# Tabisz Residence Addition & Renovations

1168 Day Road  
Sykesville, MD, 21784

Subject: Project name Tabisz Residence Addition & Renovations  
 Project site address 1168 Day Rd, Sykesville, MD, 21784  
 Permit # 322002390      SDP # \_\_\_\_\_  
 Other information pertinent to this project plan revised

**A-100**

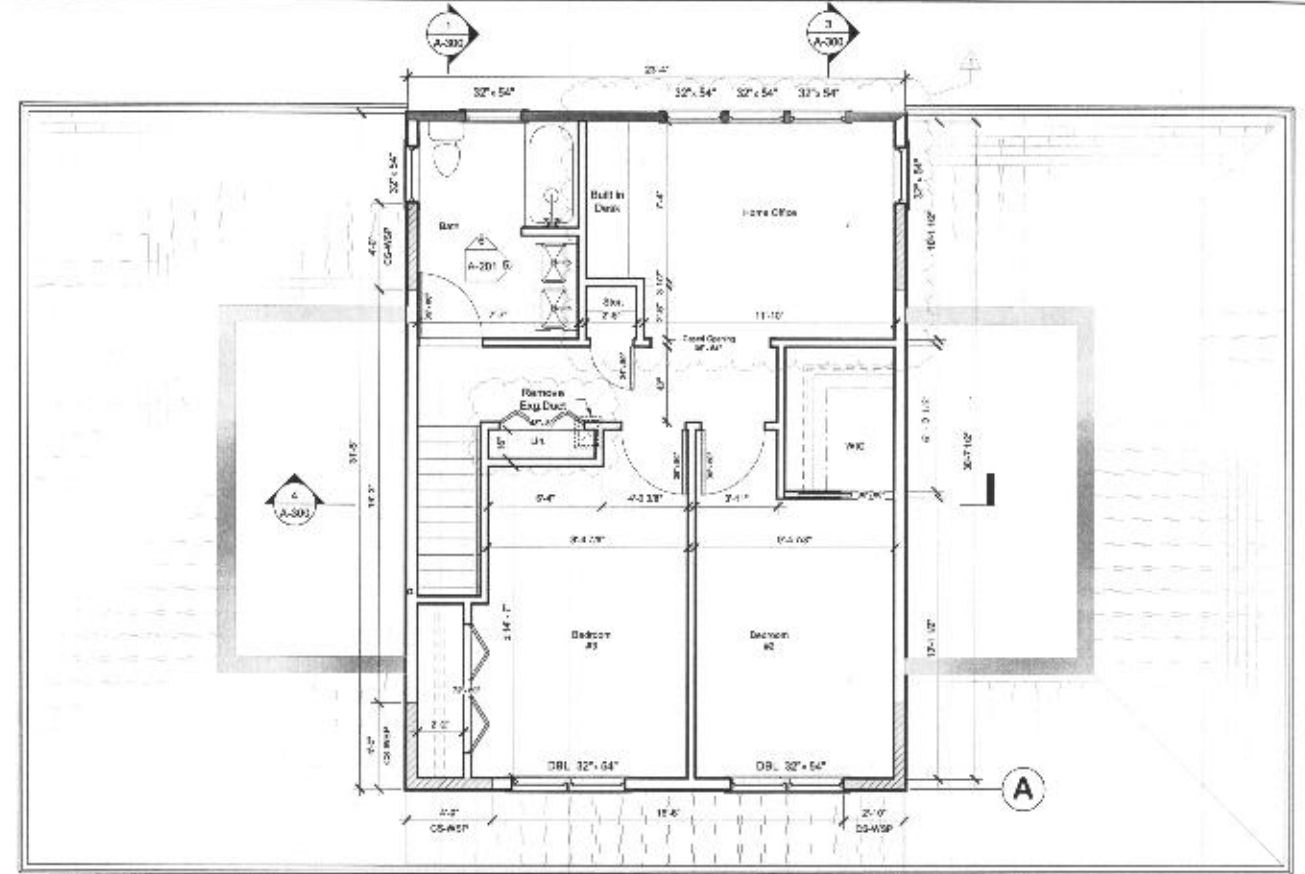
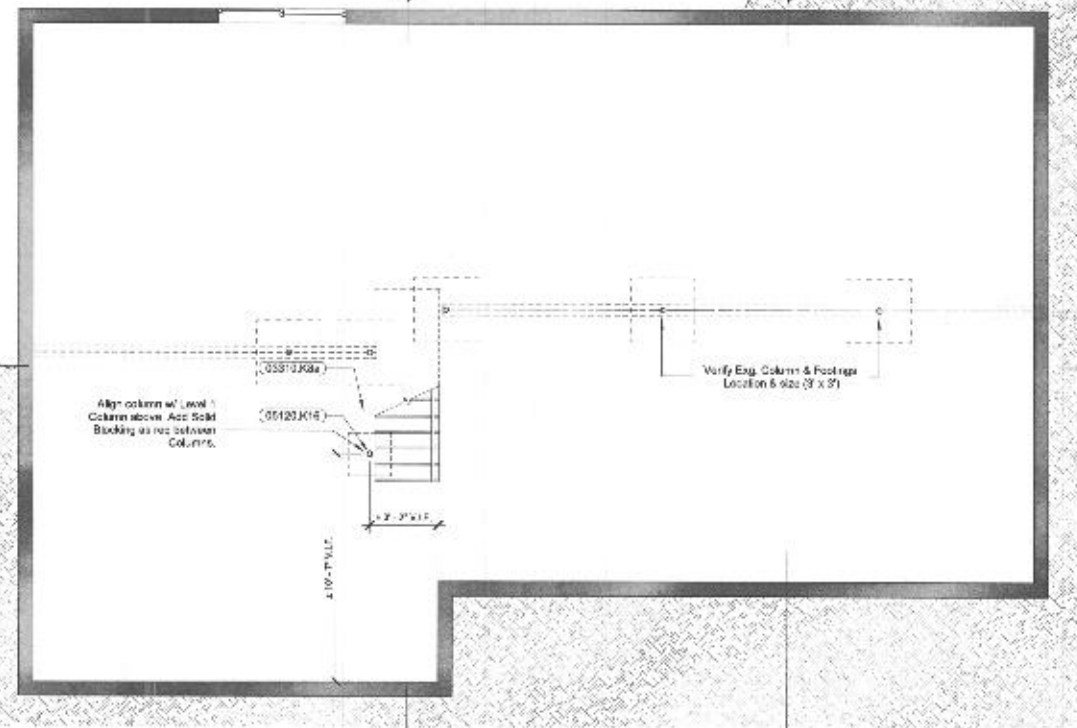
| NO. | DESCRIPTION   | DATE      |
|-----|---|-----------|
| 1   | Remove Room Features to meet Howard County Home Office Criteria. Onk Closer, Add Casp Opening & Built-in desk. Remove Exg. HVAC Duct in hallway & Enlarge Linen Closet. | 6/21/2022 |
